Access Compliance Report

Public Rights-of-Way

Intersection ID: 9302	Main Street: HIGHLAKE_DR	Cross Street: LAKECREST_DR	Location: SW
ADA ID: A8849210C651	Ramp Type: Perp	Initial Pass/Fail: Fail	Overall Compliance: No
		Severity Score: 10

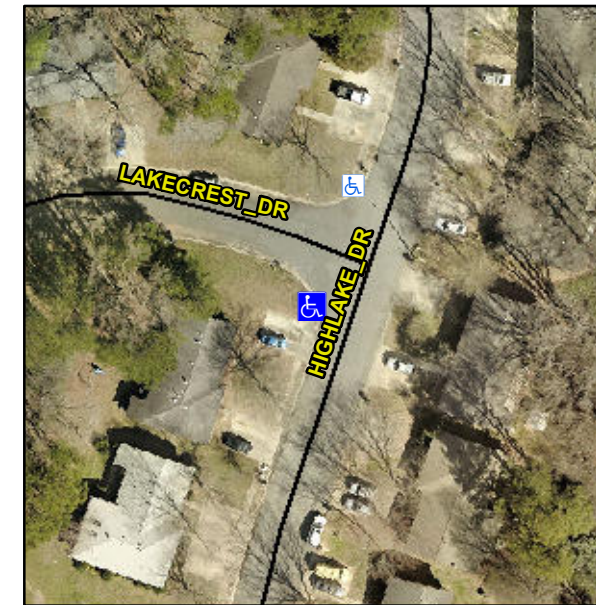
Not Found, R304.5.1, R304.5.3

Compliance	Description	Data	Compliance	Description	Data
N/A	Ramp Length (in)	50.0	Yes	Ramp Slope (%)	5.2
No	Ramp Width (in)	47.5	No	Ramp XSlope (%)	4.3
N/A	Flare Type LT	N/A	N/A	Flare Type RT	N/A
N/A	Flare Slope LT (%)	N/A	N/A	Flare Slope RT (%)	N/A
N/A	Flare Traversable LT?	N/A	N/A	Flare Traversable RT?	N/A
N/A	Landing Length (in)	N/A	N/A	DWS Provided?	N/A
N/A	Landing Width (in)	N/A	N/A	DWS Contrast?	N/A
N/A	Landing Slope (%)	N/A	N/A	DWS Length (in)	N/A
N/A	Landing X Slope (%)	N/A	N/A	DWS Full Width?	N/A
N/A	Landing Curb? (Y/N)	N/A	N/A	DWS Offset (in)	N/A
N/A	Shared Landing?	N/A			
N/A	Gutter Ponding?	N/A	N/A	Gutter Slope (%)	N/A
N/A	Gutter Lip Ht (in)	0.5	N/A	Gutter X Slope (%)	N/A
N/A	Painted X Walk1?	No	N/A	Painted X Walk2?	N/A
	X Walk 1 Direction	To NE		X Walk 2 Direction	N/A
N/A	X Walk 1 Width (in)	N/A	N/A	X Walk 2 Width (in)	N/A
	X Walk 1 Slope (%)	4.3		X Walk 2 Slope (%)	N/A
	X Walk 1 X Slope (%)	2.5		X Walk 2 X Slope (%)	N/A

Remove & Replace Entire Ramp.
